Duke Energy Corporation ONS 2 EOC-19 Preliminary Report

Revised 10/30/02

Duke Energy Corporation ONS-2 EOC-19 Preliminary Information

Attachment C: Test pressurization curve for Tube 37-27

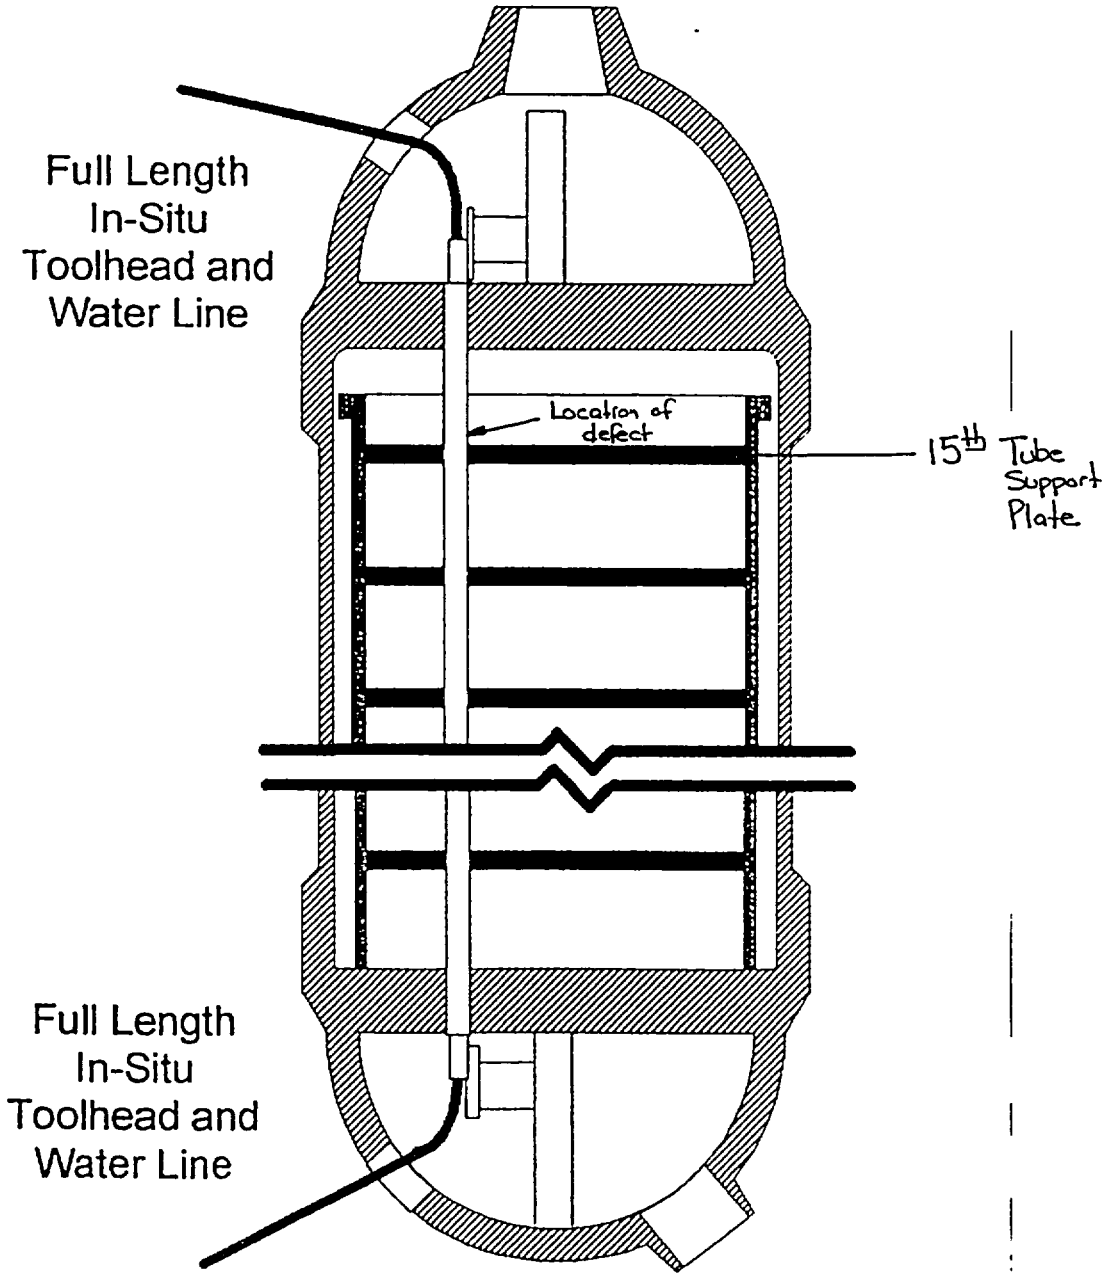
During in-situ pressure testing on OTSG 2B, Tube 37-27 failed to reach the full test pressure of 4300 psig representing the density corrected test pressure for 3 times normal delta-p. Upon reaching the 3900 psig test plateau, the hold period was just beginning and the leakage rate exceeded the capacity of the test system and pressure rapidly dropped to near zero. The in-situ test was a full length water pressure test. The defect of interest was an axial indication located at 15 TSP + 4.41 inches. The measured depth was 95% TW with a length of 2 inches.

Subsequent visual inspection indicates the axial defect at this location had opened to a gap of approx. 1/16"-1/8". Subsequent testing with a bladder was not deemed possible due to opening size. Subsequent bobbin exam indicates a length of approx 1.5 inches. MRPC exam was not performed due to likelihood that rotating element would not adequately rotate through the defect location.
